UNITED STATES PATENT AND TRADEMARK OFFICE

Office Action Summary	Application No. 10/577,372	Applicant(s) FUKUDA ET AL.	
	Examiner ROBERT A. COKER	Art Unit 3616

2. Claims 3, 5, 6, 8, 9, 11-17 are rejected under 35 U.S.C. 103(a) as being unpatentable over Heudorfer et al. (U. S. 6,394,487) in view of Hammer et al. (U. S. 6,343,811).

Figure 1A

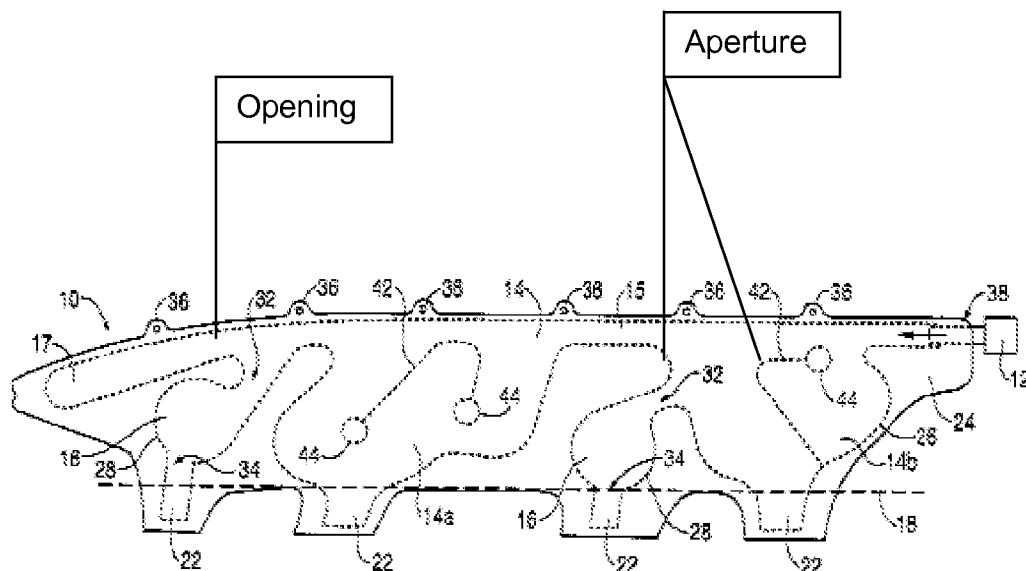
With respect to claim 3, Heudorfer et al. disclose a side curtain air bag (10), which includes chambers expanded by gas supplied from a gas generator (12), and expands and develops into a curtain shape along a side part of a vehicle so as to

protect vehicle occupants, the side curtain air bag comprising: at least one primary chamber (16) defining an aperture (wherein the aperture is the portion labeled in the drawing where the gas from the gas generator flows through into chambers 16 and 22) (See Figure 1A) that provides fluid communication between the primary chamber and the gas generator, the primary chamber being expandable by gas supplied by the gas generator so as to protect an occupant; at least one secondary chamber (17) defining an opening (wherein the opening is the portion labeled in the drawing forming entrance for the gas from the gas generator into the chamber 17) (See Figure 1A) that provides fluid communication between the secondary chamber and the gas generator, the aperture and the opening sized such that the aperture is substantially larger than the opening so that the secondary chamber begins to substantially expand and develop after the primary chamber is approximately fully expanded and developed by gas from the gas generator; and relative to when the gas is generated by the gas generator high pressure is applied initially to the primary chamber, whereas the secondary chamber gradually increases in pressure to be about the same as pressure of the primary chamber. Heudorfer et al. do not disclose at least two tethers. However, Hammer et al. disclose a first (31) and a second (33) curtain tethers. Therefore, it would have been obvious to one having ordinary skill in the art at the time the invention was made to modify the invention of Heudorfer et al., such that it comprised at least two tethers in view of the teachings of Hammer et al., so as to keep the curtain taut against the windows of the vehicle.
